Job 72418064REP1	Truss F21	Truss Type Truss	Qty 6	Ply 1	PBS\GUILFORD TRAD B 2FLR Job Reference (optional)
---------------------	--------------	---------------------	----------	----------	--

UFP Mid Atlantic LLC, 5631 S. NC 62, Burlington, NC, Chawn Duty

Job 27418064REP1	Truss F23	Truss Type Truss	Qty 5	Ply 1	PBS\GUILFORD TRAD B 2FLR Job Reference (optional)
---------------------	--------------	---------------------	----------	----------	--

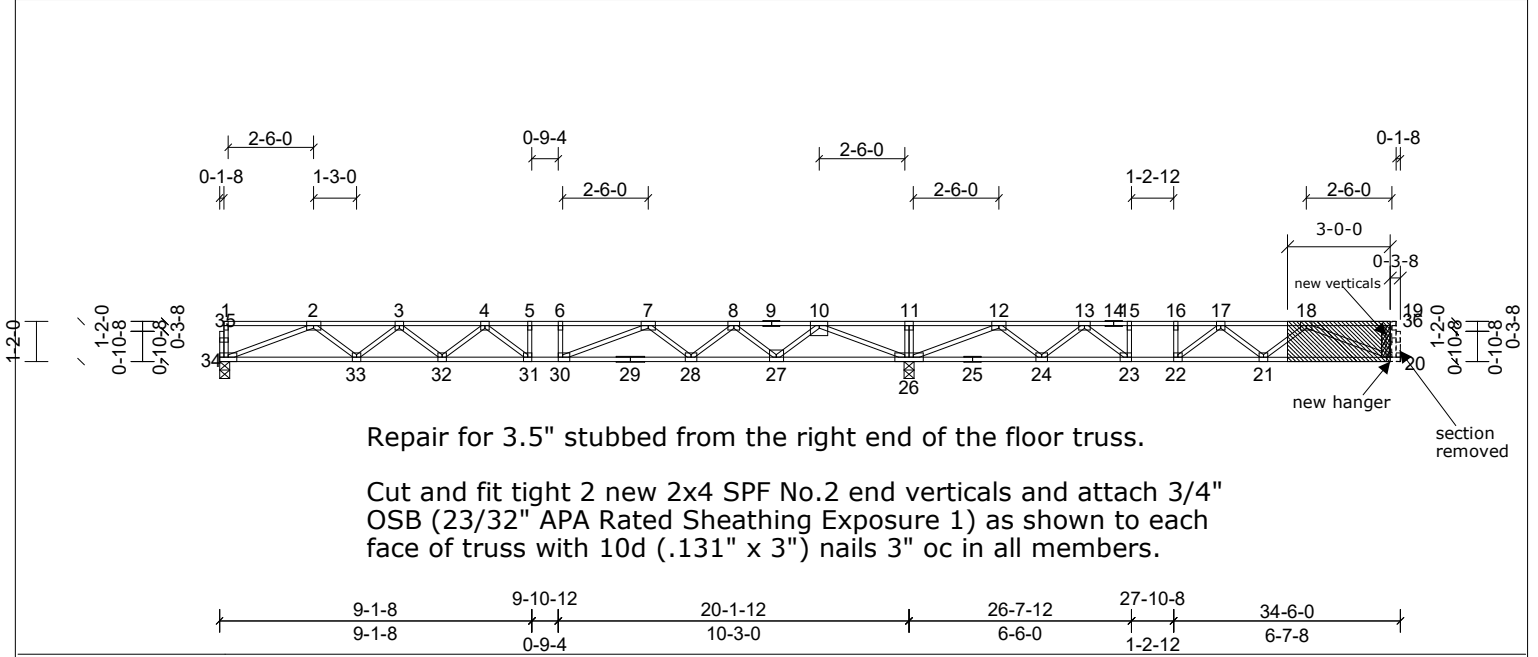
Repair for 3.5" stubbed from the right end of the floor truss.

Cut and fit tight 2 new 2x4 SPF No.2 end verticals and attach 3/4" OSB (23/32" APA Rated Sheathing Exposure 1) as shown to each face of truss with 10d (.131" x 3") nails 3" oc in all members.

Job 72418064REP1	Truss FK21	Truss Type Truss	Qty 1	Ply 1	PBS\GUILFORD TRAD B 2FLR Job Reference (optional)
---------------------	---------------	---------------------	----------	----------	--

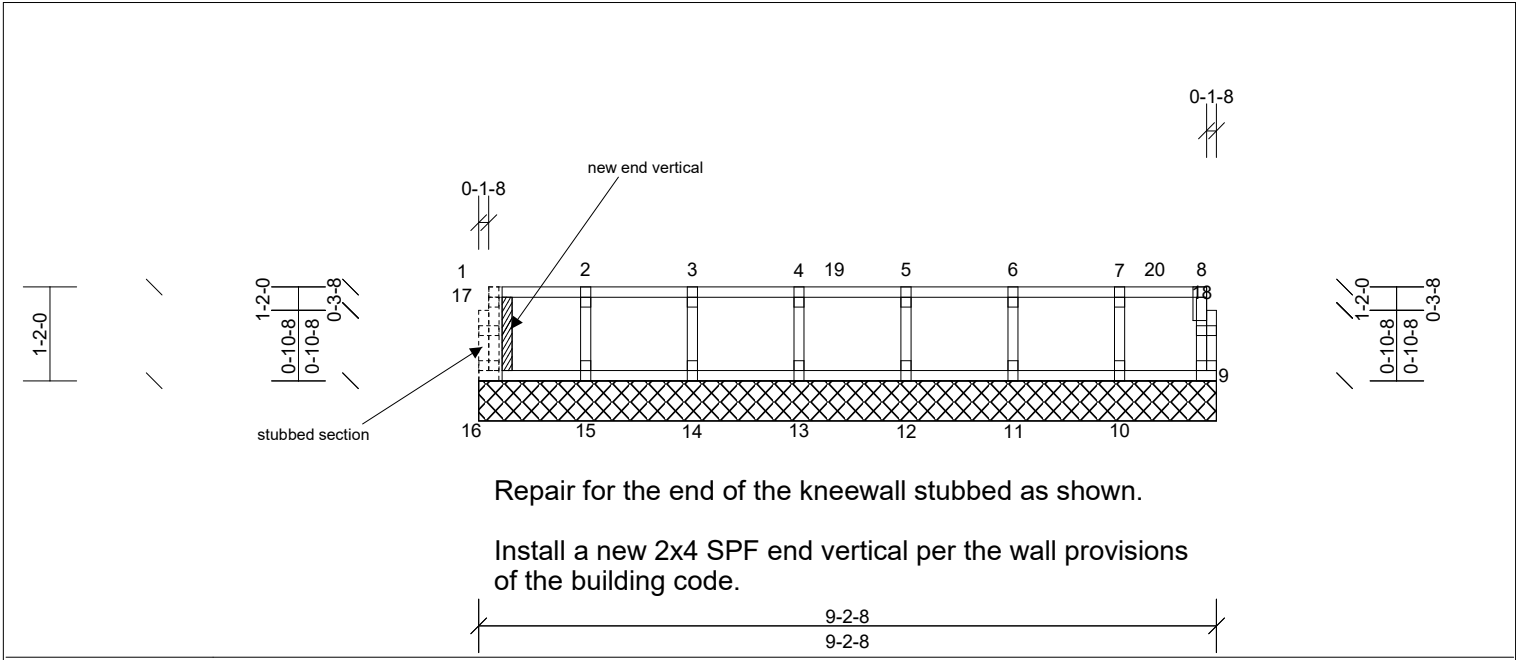
Repair for the end of the kneewall stubbed as shown.

Install a new 2x4 SPF end vertical per the wall provisions of the building code.
